Document Information			
Document #	0201741/02-RCA-0272	Revision	
Title	QUARTERLY NOTIFICATION OF CLASS 1 MODIFICATIONS TO THE HANFORD FACILITY RESOURCE CONSERVATION AND RECOVERY ACT (RCRA) PERMIT, DANGEROUS WASTE PORTION (QUARTER ENDING MARCH 31, 2002 - PERMIT CONDITION I.C.3)		
Date	04/09/2002		
Originator	J. HEBDON, R. H. GURSKE, R. D. (ROBY) <i>ENG E</i>	Originator Co.	DOE, FH, PNNL
Recipient	L. E. RUUD	Recipient Co.	DOEC
References			
Keywords			
Projects			
Other Information

FMP-CS (Facility Modification Package - Coversheet) (Block 17, 18, 22)*

1. Mod Title: Change to ECN-664331			
2. USQ Required? USQ # _____ N/A _____ CX # _____ N/A _____		3. Assigned Lead Engineer: H.L. Roach	4. Design Authority: S.T. Willett
5. Project No./Work Package No.: EL-00-00712/M	6. Area 200E	7. Building 2025E	8. System No.: 60J
9. Related FMPs/Changes:	10. Incorporates ECN/DCNs:	11. Contract Mod. No.:	12. Change Proposal No.:
13. Lead Engineering Discipline:	14. Affected Engineering Disciplines:

15. Change Description (description and reason for requested change):
 Drain pipe upstream of valve 60J-107 needs to be capped. A detail is provided for capping this drain with applicable changes to th

FMP Section Title	SKT-1	Date	12/06/01	H-2-88989-1/Rev 19
-------------------	-------	------	----------	--------------------

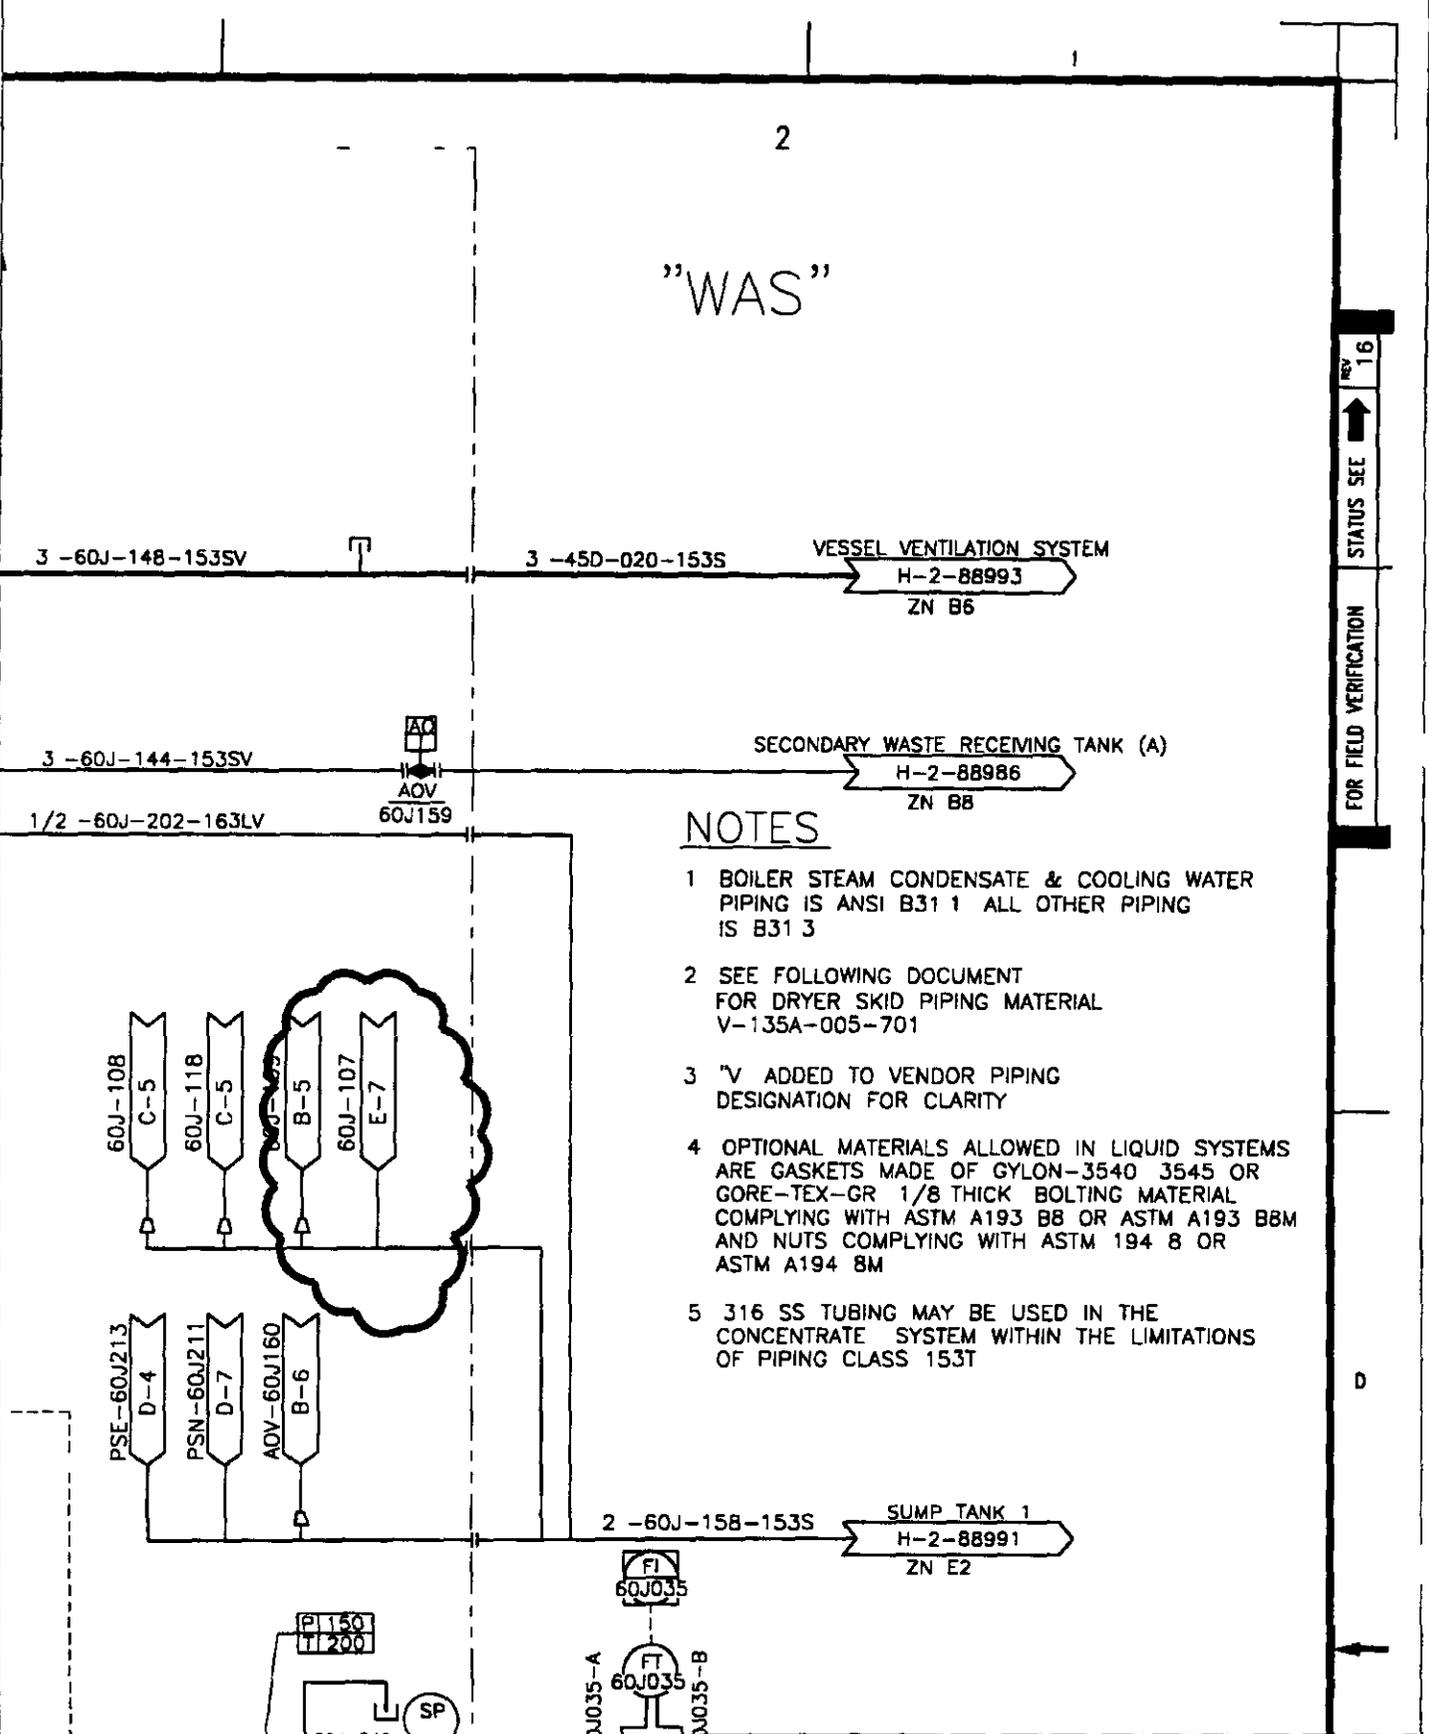
The drain pipe upstream from valve 60J-107 needs to be capped. To make it easier to reuse this drain in the future a plug will be installed at the existing union connection just upstream from valve 60J-107. An additional change to the P&ID, H-2-88989-1 is required.

NEW PIPE SUPPORT ASSEMBLY

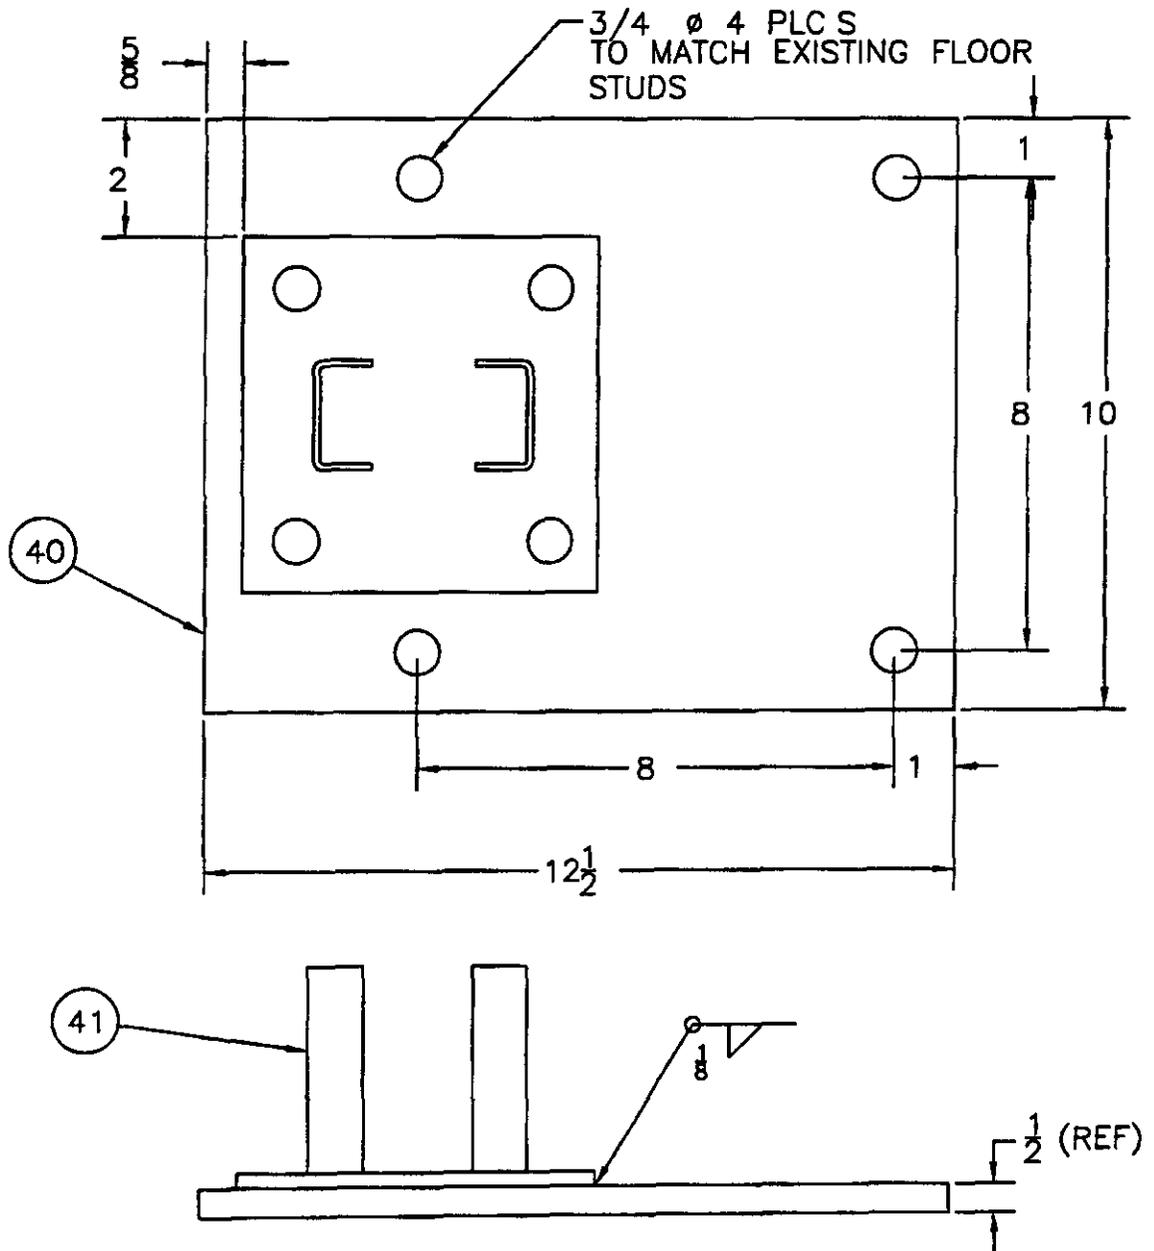
A new pipe stand will be designed to support pipelines ¾"-1B-031-151, ¾"-95D-015-155, and the 1-1/2" drain line connection to (removed) valve PSV-60J212. New pipe support will allow for an existing pipe support to be removed and will provide an additional 13" walk way clearance around the Thin Film Dryer. Pipe load on the new support is minimal so stress analysis is not required.

PSV-60J212 DRAIN BLANK

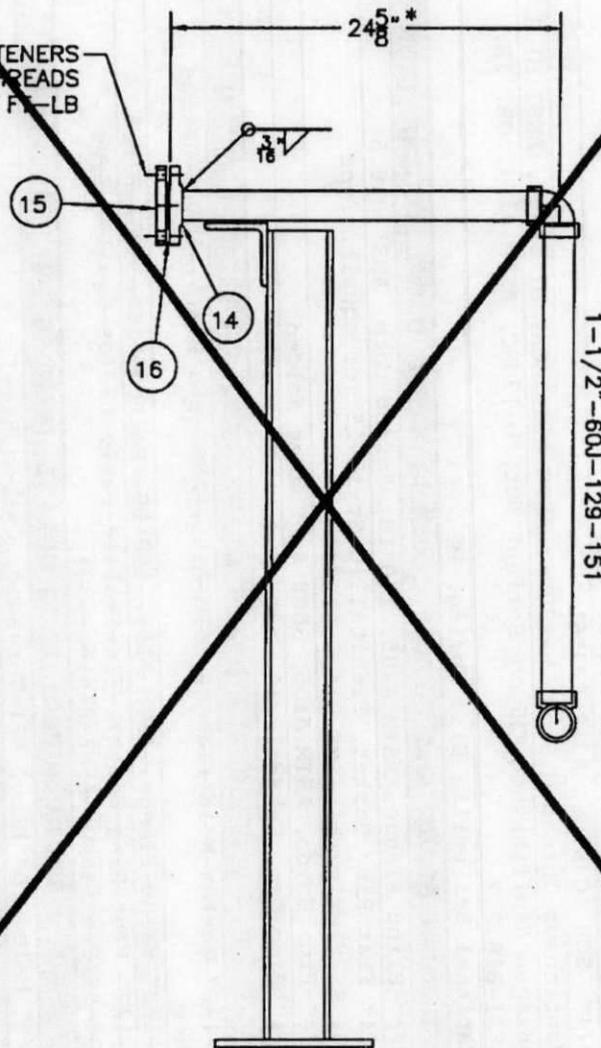
USE EXISTING FASTENERS
LUBRICATE ALL THREADS
TORQUE TO 25-27 FT-LB

Ref. Des. H-2-817969	Sh. 1	Rev. 0	Prepared By RC CROSKREY	Checked By <i>[Signature]</i>	ECN No. W-291H-15	P. C. 5
-------------------------	----------	-----------	----------------------------	----------------------------------	----------------------	------------

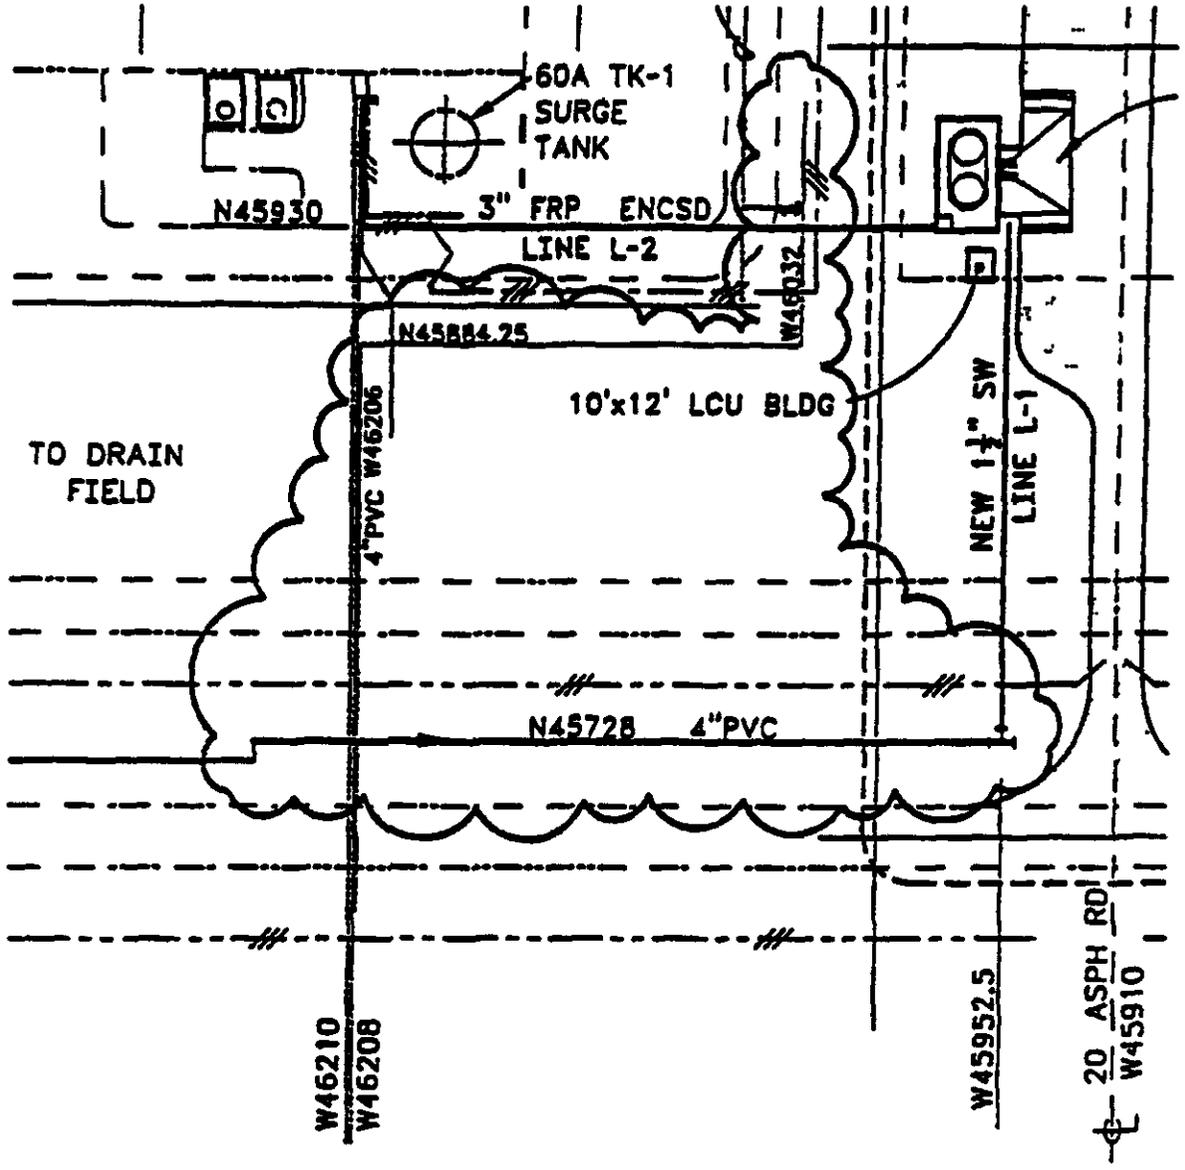
12 Description of Change SC/3
ITEM 1 DWG H-2-817969 SHT 1
 a ZONE C-4, Change alignment of line and add line as shown in sketch on page 5

a AF, Sanitary Water line must be moved to avoid leak detection risers installed by project C-018 4 lined installed by project C-018 is added

Ref. Des.	St.	Rev.	Prepared By	Checked By	ECH No.	Page
H-2-817969	2	0	RC CROSKREY	<i>[Signature]</i>	W-291H-15	7/10

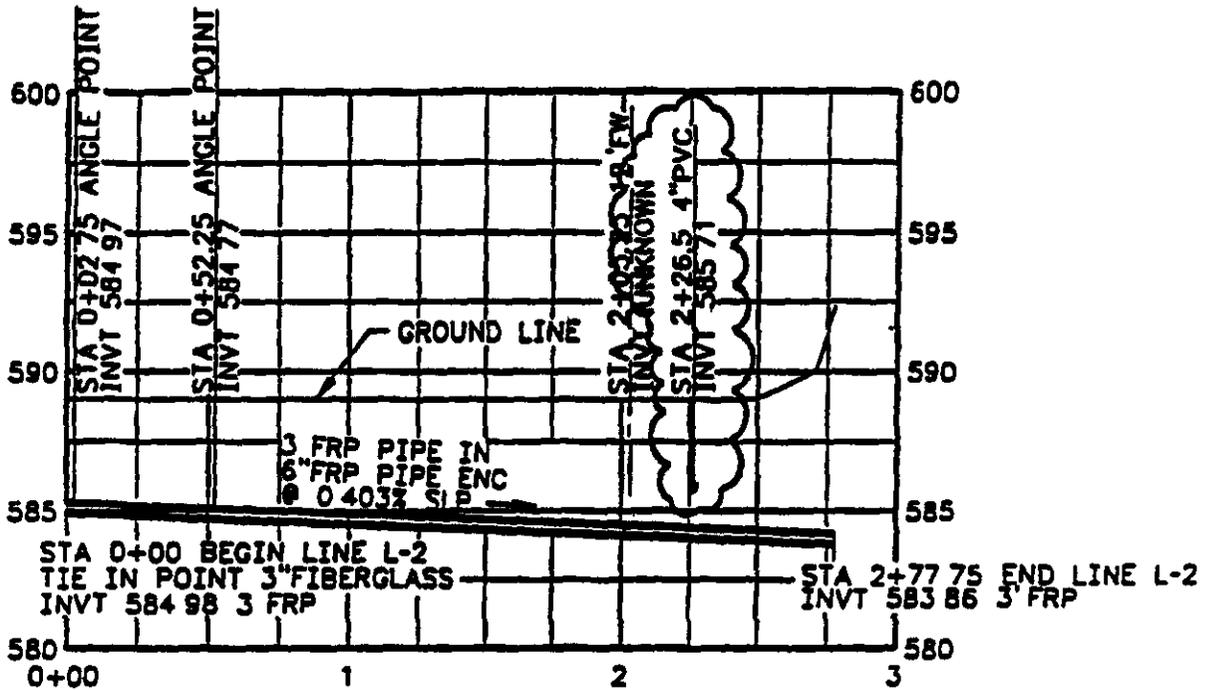
ITEM 2 DWG H-2-817969 SHT 2
 a Zone DE-3,4, Change alignment of line L-1 and add 4" line as shown in sketch on page 6
 b Zone AB-7, Change and add line to profile as shown in sketch on page 7
 c Zone D-7, Change notes as shown in sketch on page 8
 d Zone B-6, Change detail as shown in sketch on page 8 Related ECN W291H-2/10
 e Zone B-1, Change note 3 to read as follows
 3 The 4" PVC pipe for line L-1 shall be IAW pipe code A or B of section 02650 of the spec

- a AF, Same as Item 1a
- b AF, 4" line installed by C-018 crosses line L-2 and is added to profile
- c DI, Redundancy in note is removed
- d FC, Pipe material as called out on the drawing made fabrication of pipe expensive and time consuming

H 2 88766. Sheet 4. Rev 2. Zone D 2

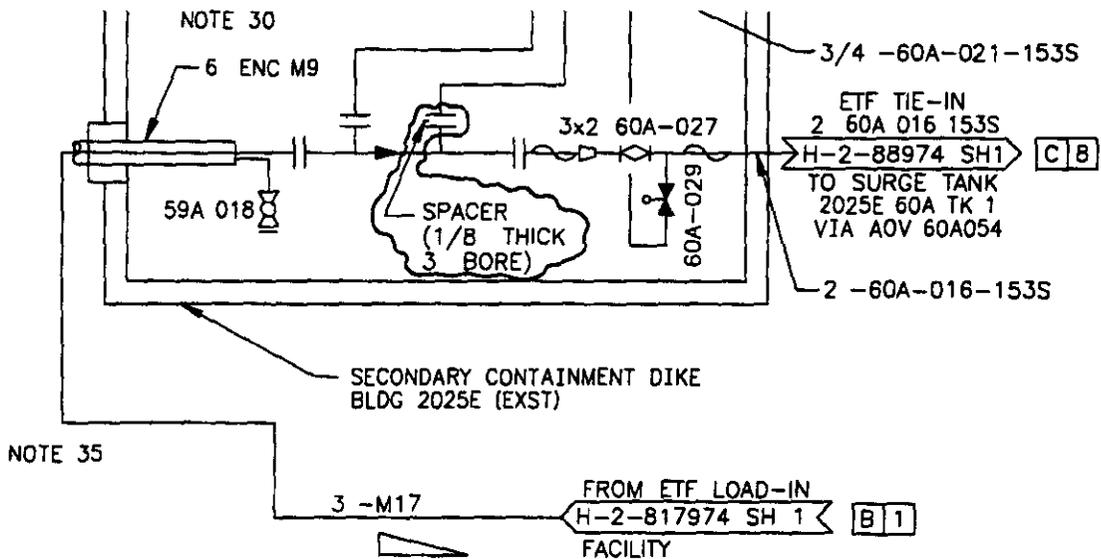
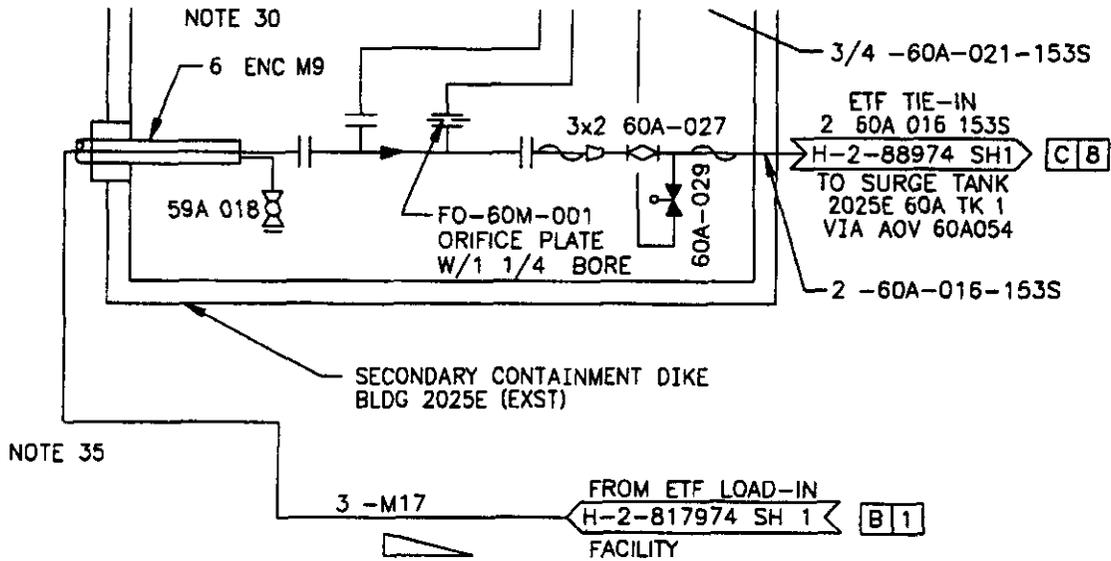
- Remove flow orifice in System 60M transfer line from Load In Station
- As build sample valve and tanker vent valving
- Add drain lines and valves to Load In Station pump cases
- Add bell reducer funnels and valving to suction of Load In Station pumps
- Replace Facility with Station in all Load In drawing titles
- Identify status of Load In Station drawings to Essential or Support

Remove flow orifice in transfer line from Load In Station to increase flow rate
 As build sample valve and tanker vent valving for configuration control
 Add drain lines and valves to Load In Station pump cases for improved contamination control
 Add bell reducer funnels and valving to allow priming of Load In Station pumps
 Replace Facility with Station in drawing titles to reflect the status of the Load In Station as part of the 200 Area ETF rather than a stand alone facility
 Identify status of Load In Station drawings to Essential or Support as appropriate

H 2 88779. Sheet 4. Rev. 0. Zone B 2

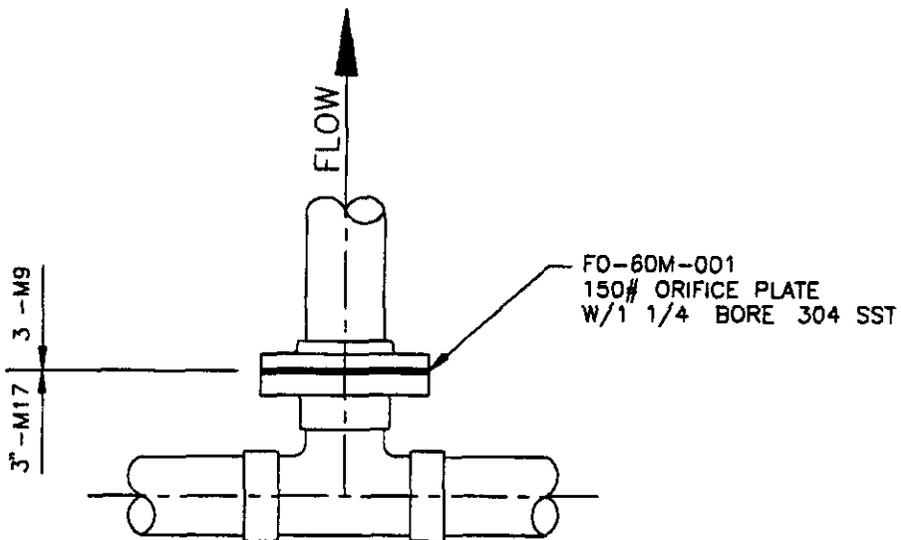
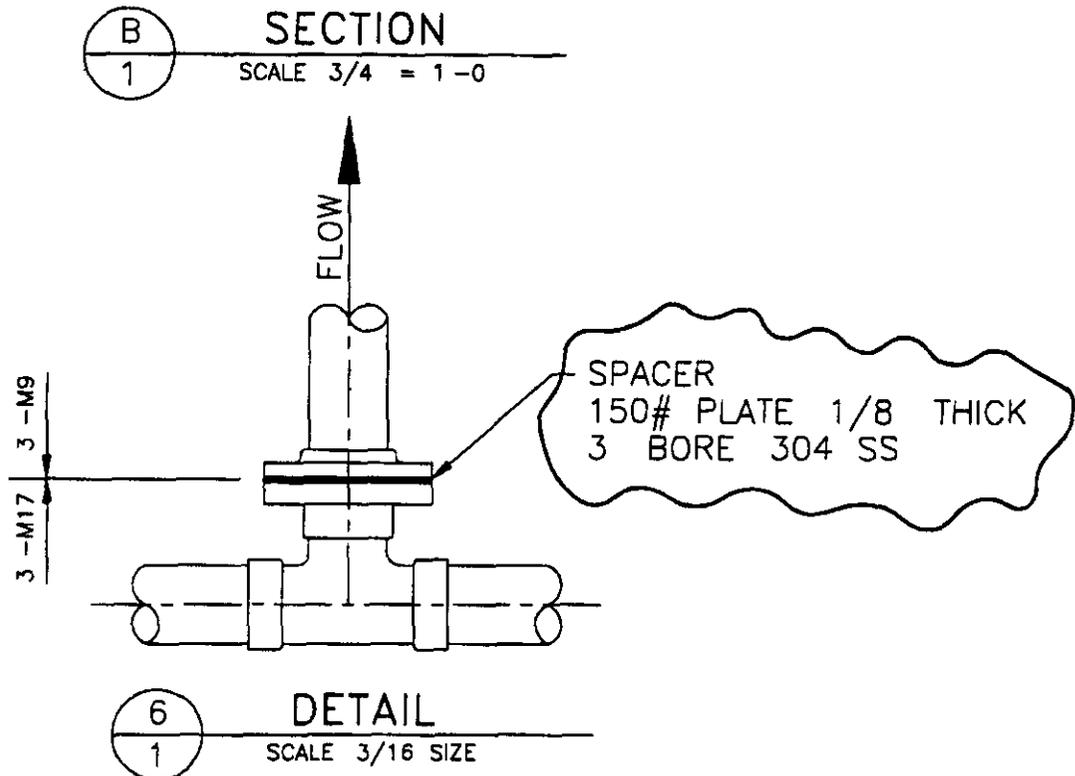
Sketch for 3 spacer shown in above changes to H 2 88779 and H 2 88766
